**GOVERNMENT OF THE DISTRICT OF COLUMBIA
DEPARTMENT OF TRANSPORTATION**

MEMORANDUM

SUBJECT: ZC Case No. 16-11 – Bruce Monroe PUD

Figure 1 Site Plan

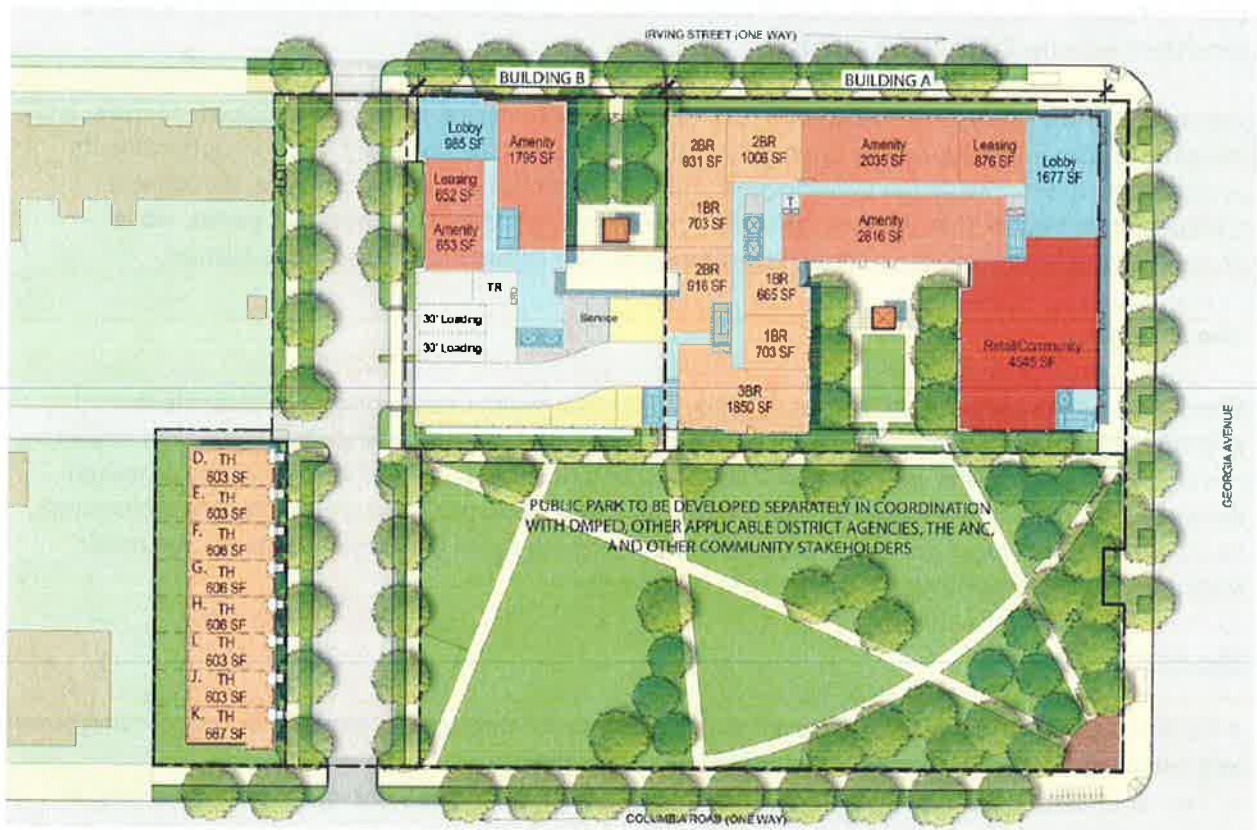
As shown in Figure 1, vehicle site access for the multifamily building is proposed from a curb cut on the north-south street. A second curb cut is proposed immediately adjacent to provide access to loading. These curb cuts do not meet DDOT standards for separation between commercial curb cuts. However, the curb cuts are located on a private street not subject to DDOT standards.

The eight townhomes are proposed to front the north-south street. Eight of the 16 proposed curbside vehicle parking spaces on the west side of the north-south street are dedicated to the townhomes.

The Applicant proposes two 30-foot berths and a 20-foot service space in and seeks relief from two 55-foot berths. The two proposed loading berths require back-in/front-out movements from the north-south street. Although the street is a private street and therefore not subject to DDOT standards that prohibit backing movements through public space, DDOT’s preference would to provide loading access with head-in/head-out movements in order to minimize multimodal conflicts.

To mitigate potential impacts of backing movements and the requested relief from zoning-required loading facilities, the Applicant proposes the following loading management plan, which is appropriate:
